1. Waterloo Metro Quarter Over Station Development – Response to Authority Comments – Northern Precinct (SSD – 10440)

ptc. have been engaged by WL Developer Trust (WLD) to prepare a response to the traffic and parking related comments raised by the authorities in relation to the proposed Waterloo Metro Quarter Over Station Development, Northern Precinct (SSD – 10440).

Attachment 2 - Southern Loading Dock Swept Path Assessment

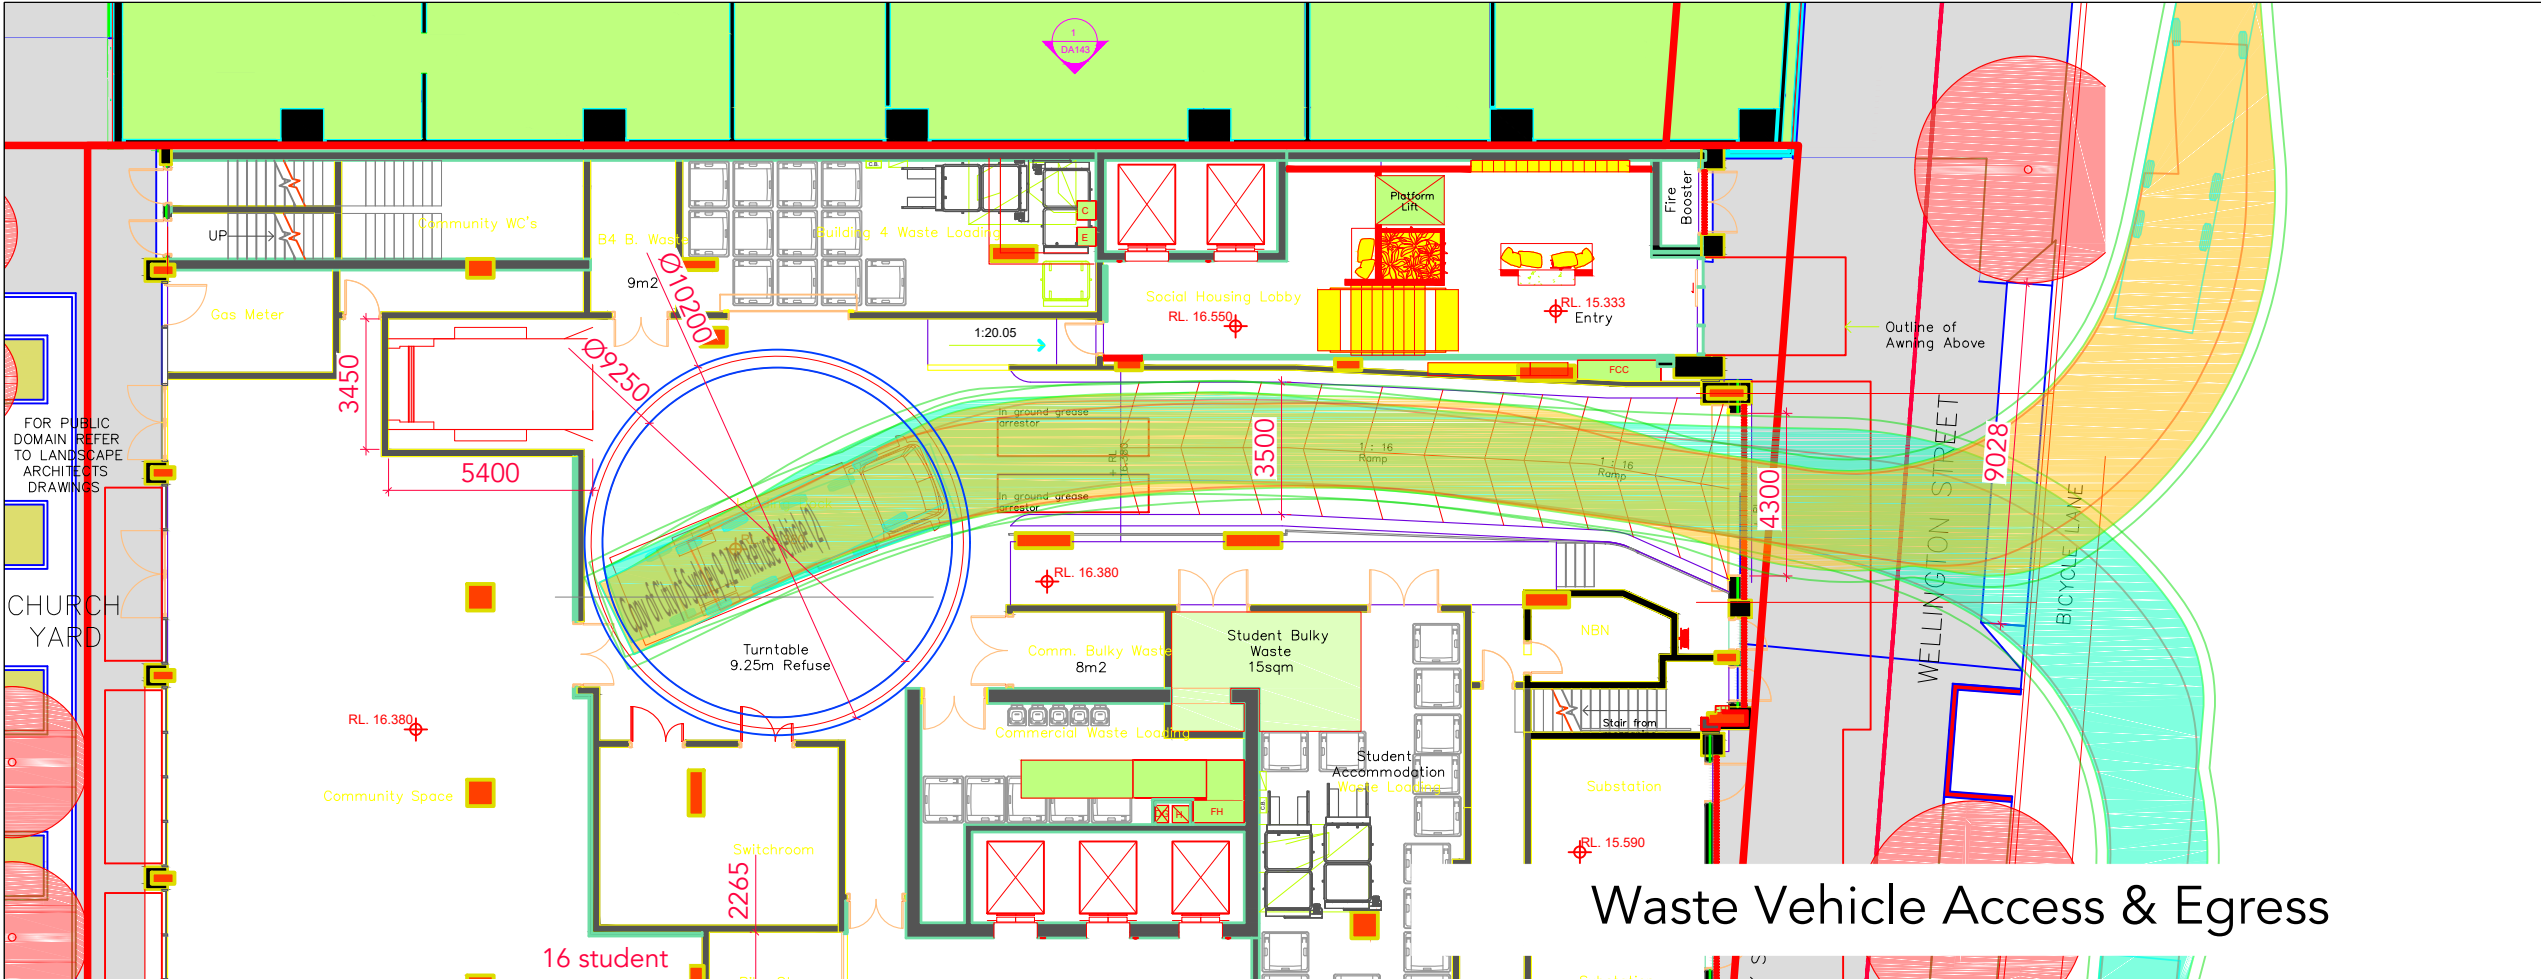
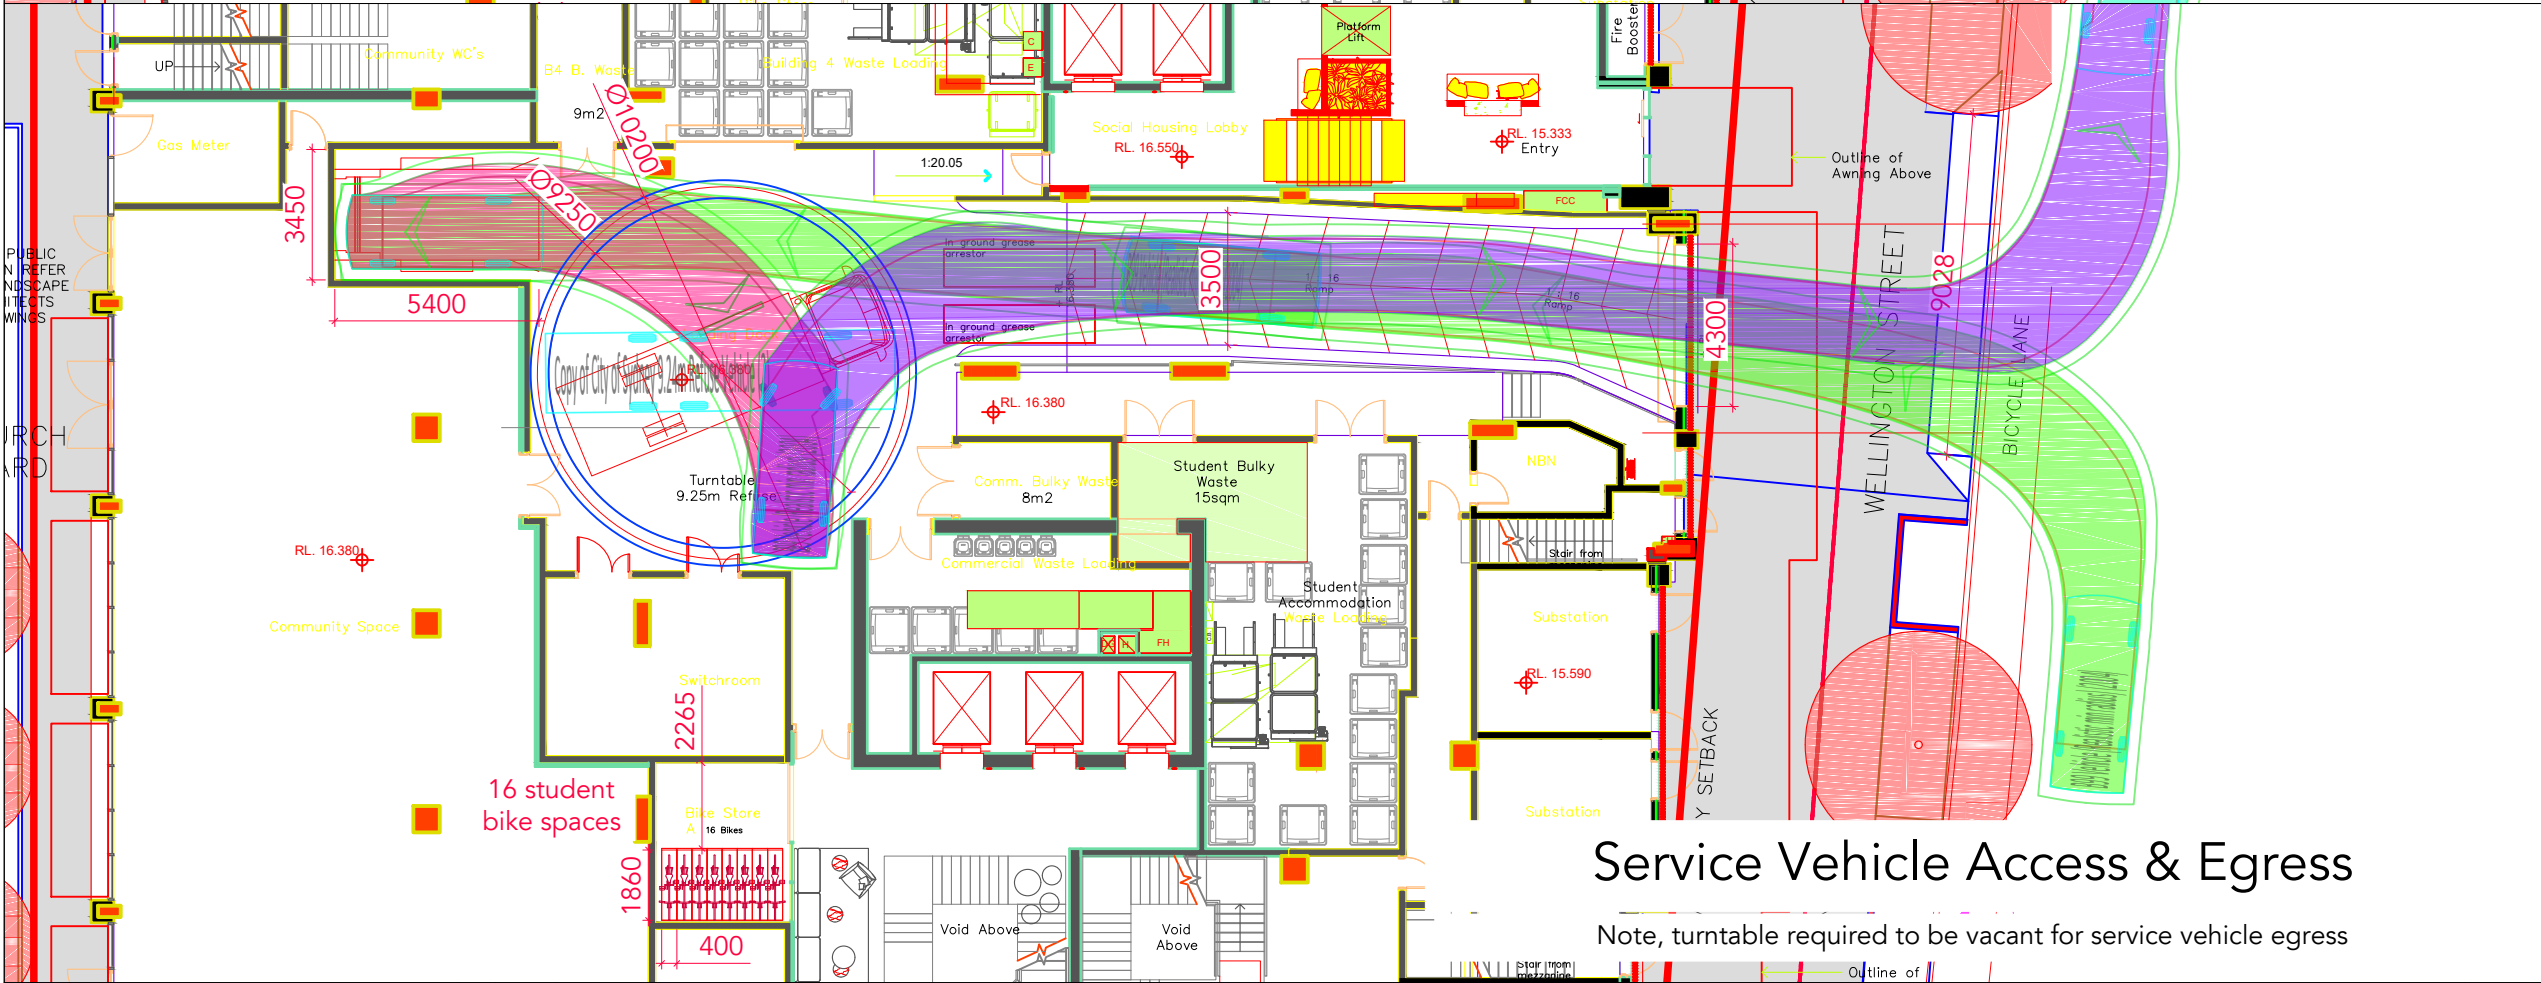
The proposal presents a shortfall of loading and servicing and should be provided as per the SDCP 2012 rates.

It should also be noted that the Southern Loading Dock has been amended to provide an additional B99 courier service vehicle bay. The revised concept loading dock layout has been reviewed and a swept path assessment has been undertaken. A B99 vehicle is able to enter the site in a forward direction upon entry

and egress from the loading dock in a forward direction is also achieved. It is noted that the egress of the B99 courier/service vehicle will require the turntable to be vacant. This can be readily managed as deliveries and maintenance vehicles are managed through the site-wide online booking system.

Overall, ptc.'s review finds that the concept design for the Southern Loading Dock generally meets or is capable of complying with AS2890.1:2004 and AS2890.2:2018. Details of the swept path assessment is provided in Attachment 2.
